SUNDRY NOTICES AND REPORTS

8. Well Name and No.
LEA SOUTH 25 FEDERAL COM 1BS 11H ✓

PECOS DISTRICT CONDITIONS OF APPROVAL

Lea South 25 Fed Com 1BS 11H Drilling Sundry

System Drawing

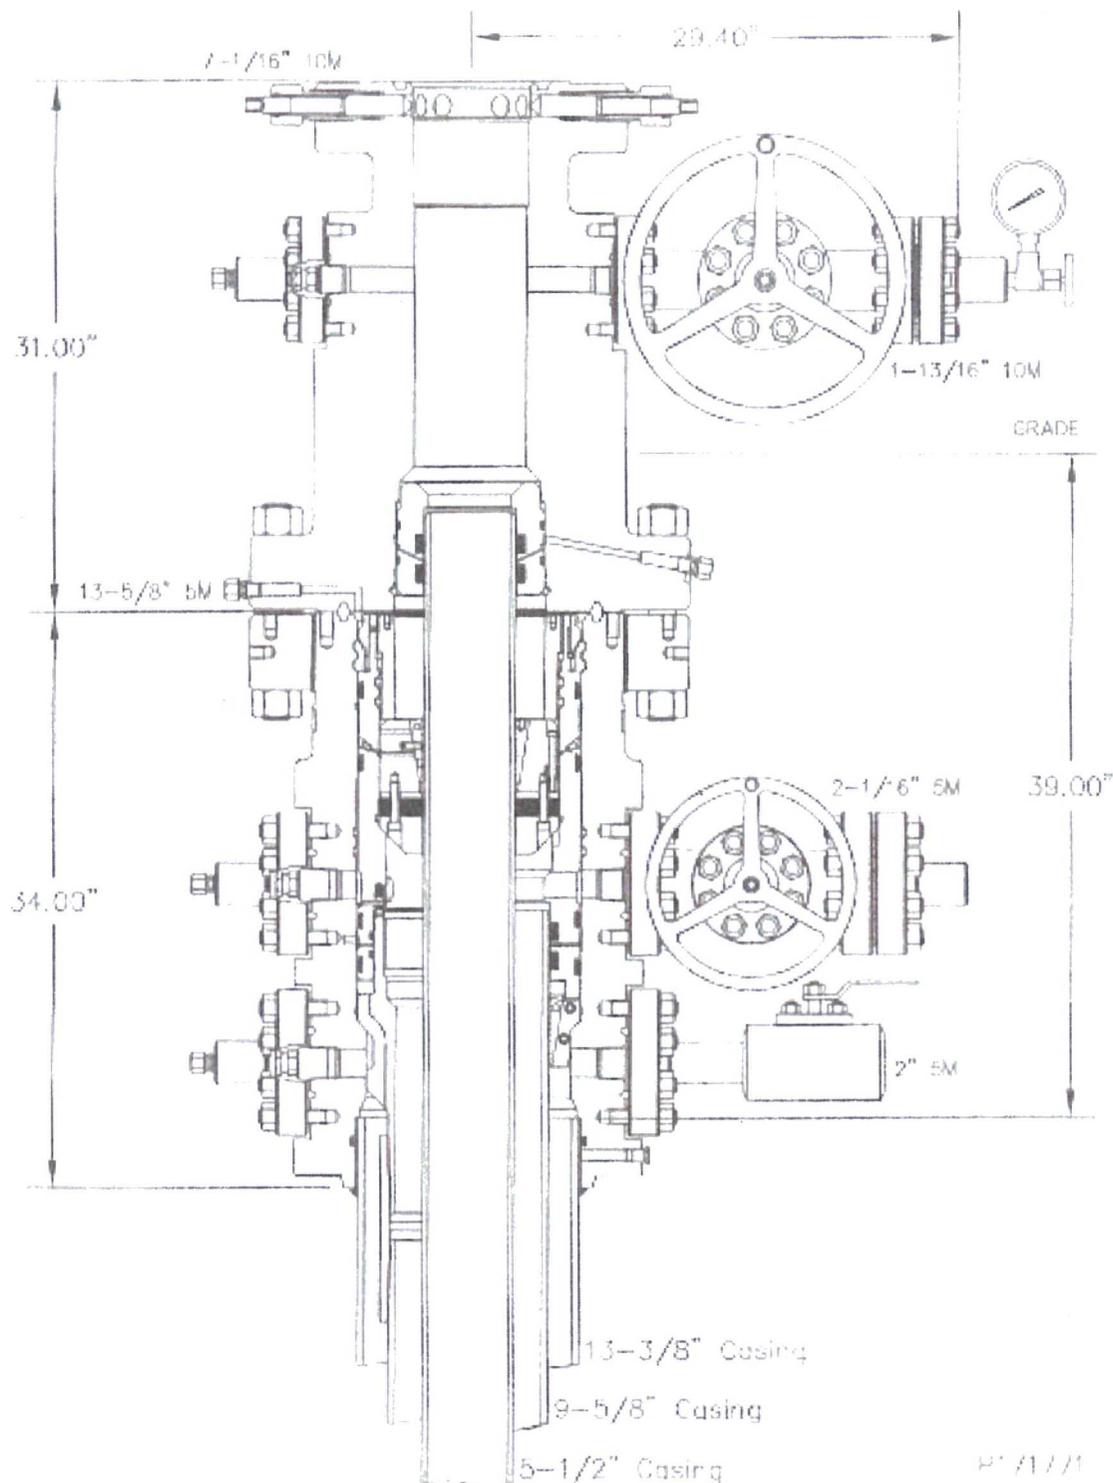
d) We will be running a Cactus speed head. (see attached)

d) Notice that we will be running a Cactus speed head on this well.

1. **Operator has proposed a multi-bowl wellhead assembly. This assembly will only be tested when installed on the surface casing. Minimum working pressure of the blowout preventer (BOP) and related equipment (BOPE) required for drilling below the surface casing shoe shall be 3000 (3M) psi.**

- a. **Wellhead shall be installed by manufacturer's representatives, submit documentation with subsequent sundry.**
 - b. **If the welding is performed by a third party, the manufacturer's representative shall monitor the temperature to verify that it does not exceed the maximum temperature of the seal.**

- c. **Manufacturer representative shall install the test plug for the initial BOP test.**
 - d. **If the cement does not circulate and one inch operations would have been possible with a standard wellhead, the well head shall be cut off, cementing operations performed and another wellhead installed.**
